## Arklow Flood Relief Scheme

Response to Submissions relating to  
Planning & Environmental Matters  
(ABP ref 301368-21 & 310377-21)

D5246

Issue | 12 January 2022

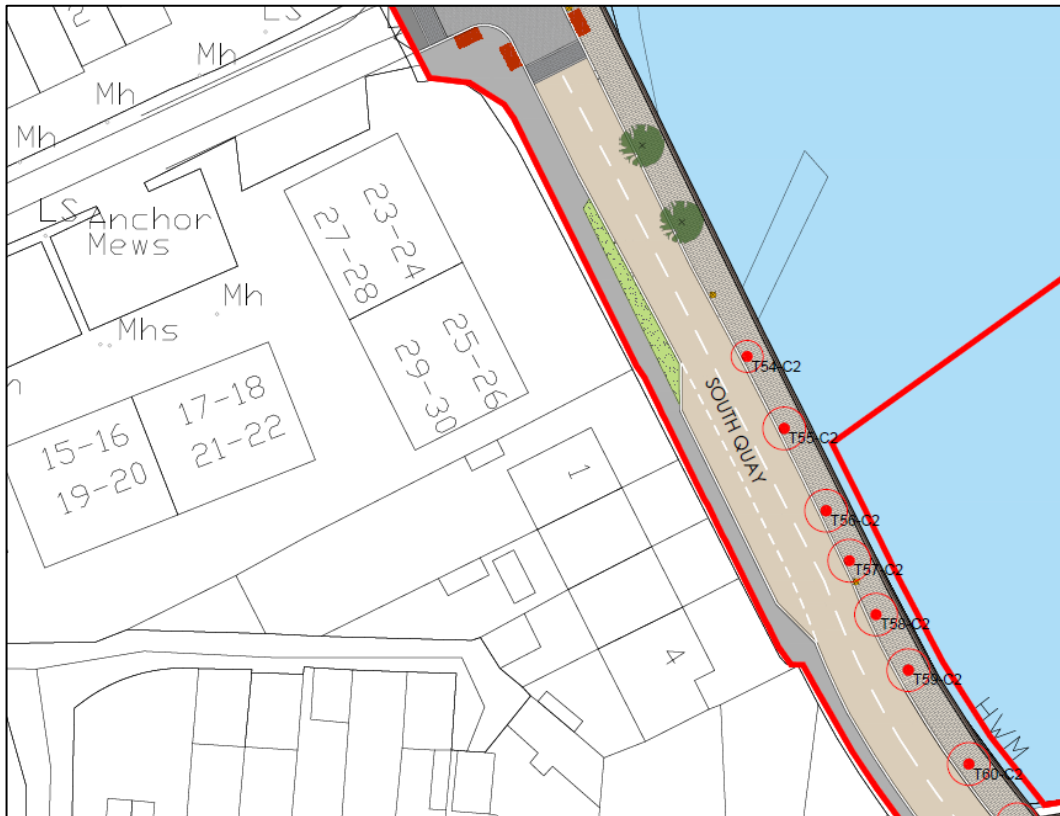
The current Public Realm Enhancement Plan for the South Quay (Drawing No 303 of Appendix 4.2 of the EIAR) does include the widening of the existing footpath opposite No's 1 to 4 on South Quay along with a narrowing of the road carriageway and the replacement of the existing grass verge on the seaward side of the road with a wider footpath, the existing trees are to be retained along this section of roadway. The current proposed layout can be seen in the figure below.

Drawing No 303 of Appendix 4.2 (*Landscape Design and Public Realm Drawings*) of the EIAR has been revised and is included in **Appendix A** of this report). This change has been included in the Schedule of Additional Environmental Commitments in Section 20 below.

**Figure 9.2: Visibility in advance of pedestrian dropped kerbs**

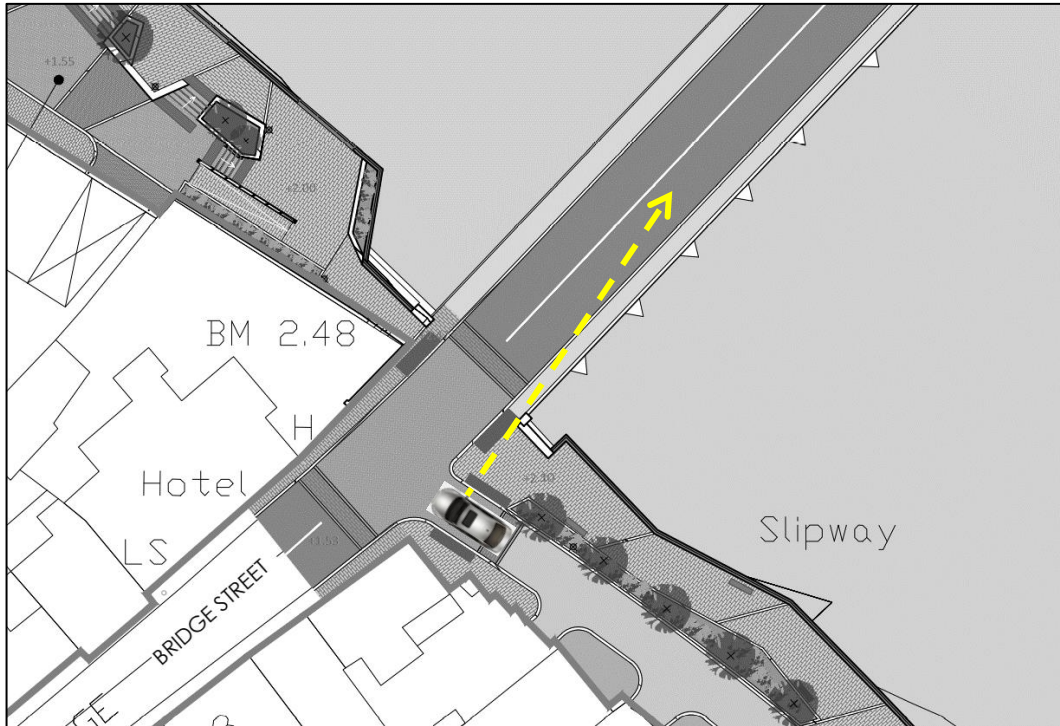
One of submissions shows the required visibility in advance of the pedestrian dropped kerbs and states that it has been impacted by a proposed new tree. This is not correct. The correct visibility is noted in Figure 9.2 below and the tree is well positioned out of any required sightline.

Date: 13.03.18	Scale: 1/500	Drawn: NM	Chk: SH	App: KT
Project No: PH00886/01	Dwg. No: 1036			Rev: P8

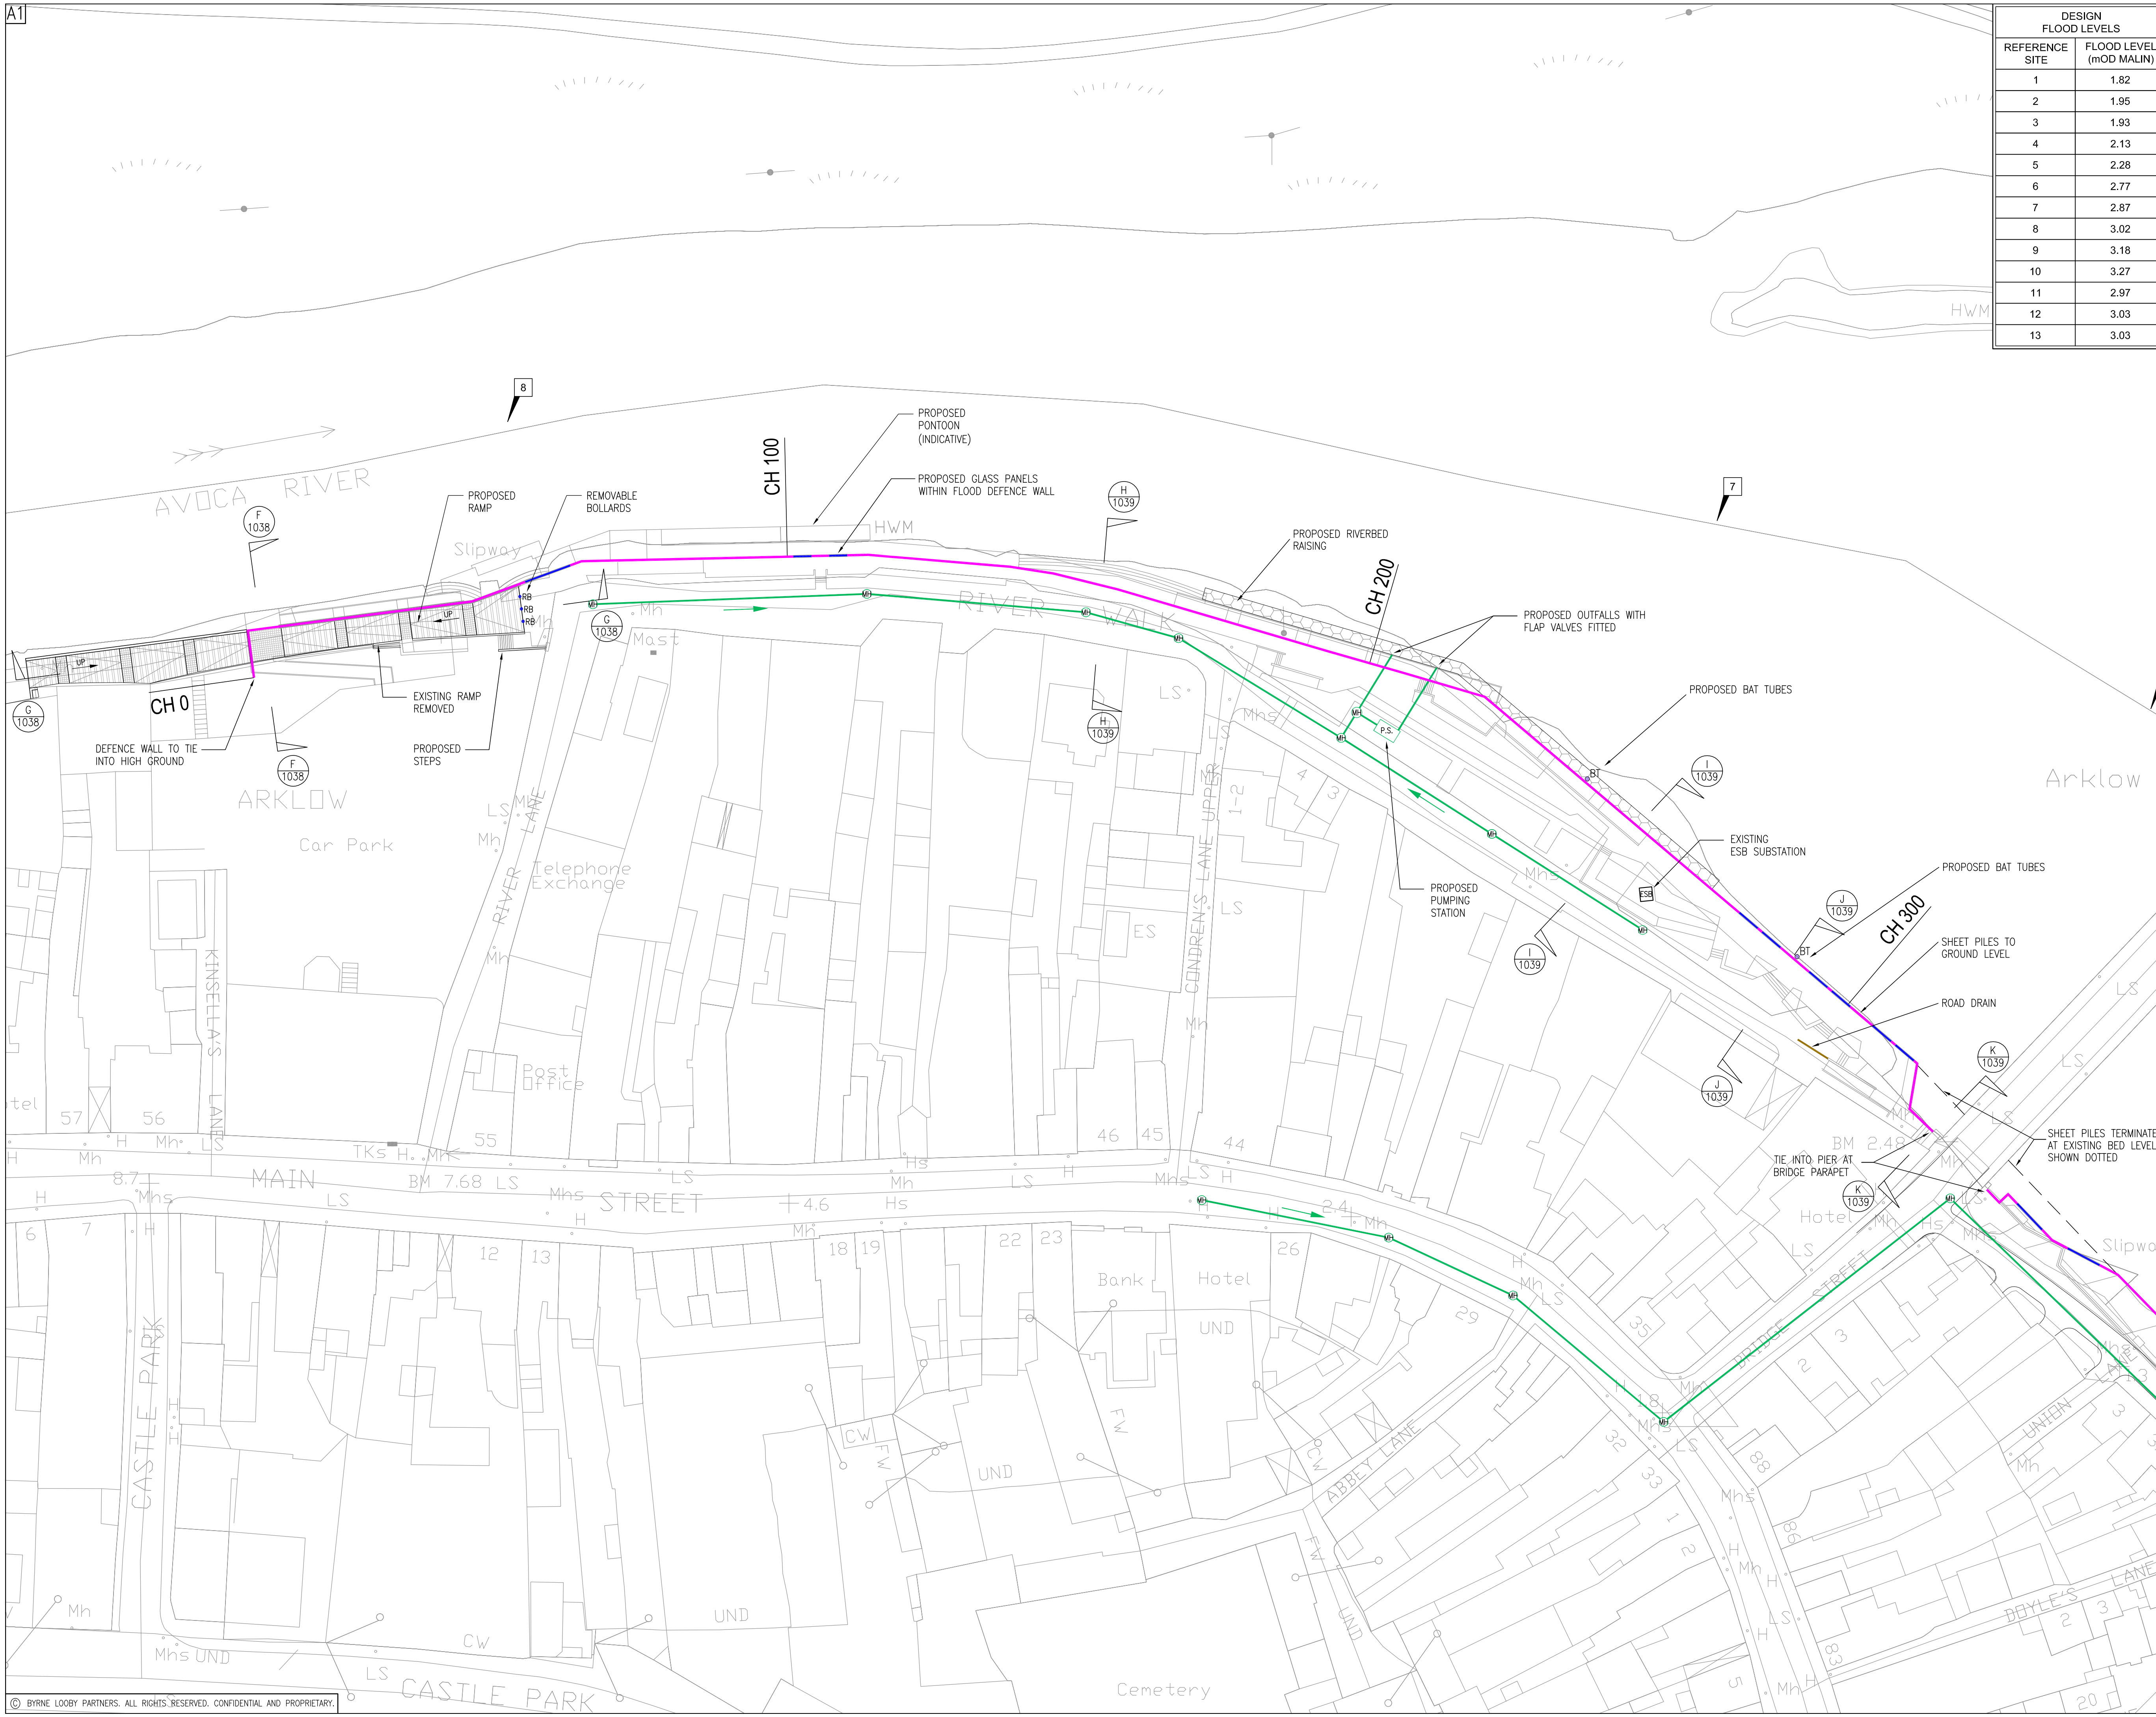
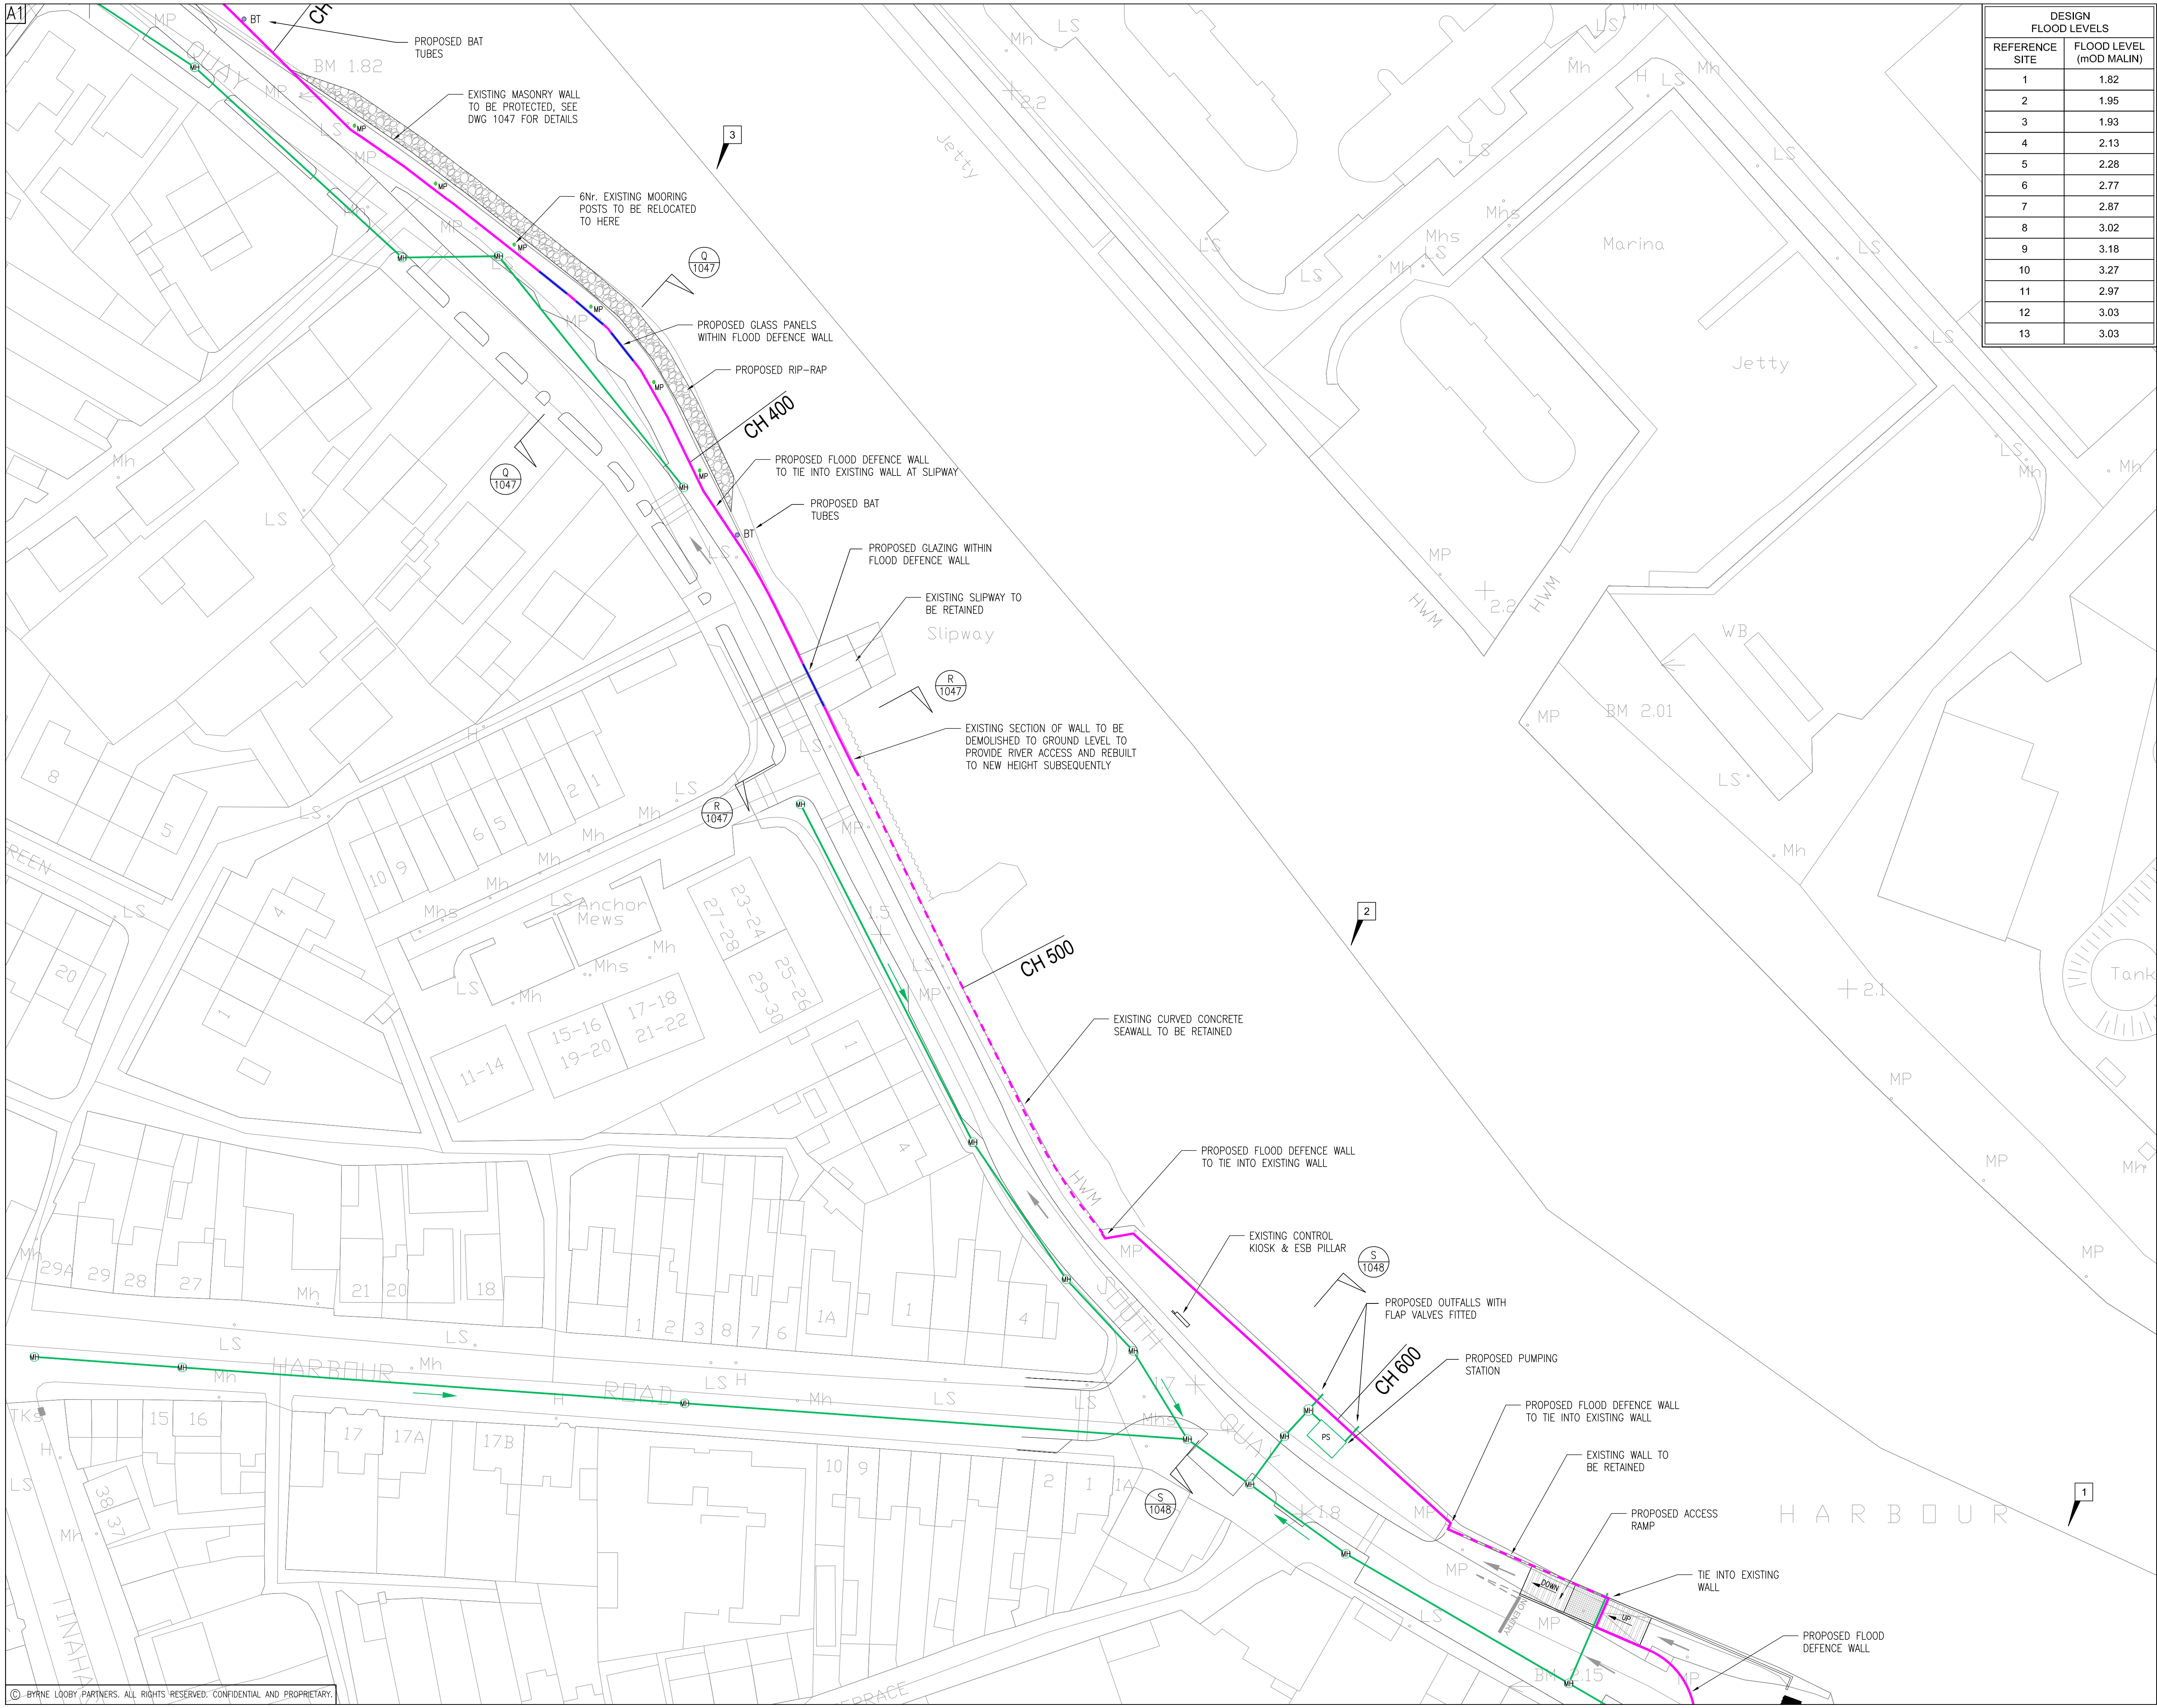
In response to the submissions/objections received by ABP, it is now proposed to include an additional 30.0m of glazing at the following locations listed below. Drawing Nos 1036-1042 and 1046 of Appendix 4.1 (*Scheme Drawings*) and Drawing Nos 301-302 of Appendix 4.2 (*Landscape Design and Public Realm Drawings*) of the EIAR have been revised to reflect these changes and are included in **Appendix A** of this report.

- Addition of two 6.0m long glass panels just downstream of Arklow Bridge on South Quay at approximately Ch 020 (12.0m total), as shown on revised Scheme Drawing No 1040 and revised Landscape Design and Public Realm Drawing No 301 in **Appendix A** of this report. This will open up views of the bridge downstream.
- Addition of three 6.0m long glass panels along South Quay at approximately Chainage 370 (18.0m total), as shown on revised Scheme Drawing No 1041 and revised Landscape Design and Public Realm Drawing No 302 in **Appendix A** of this report.
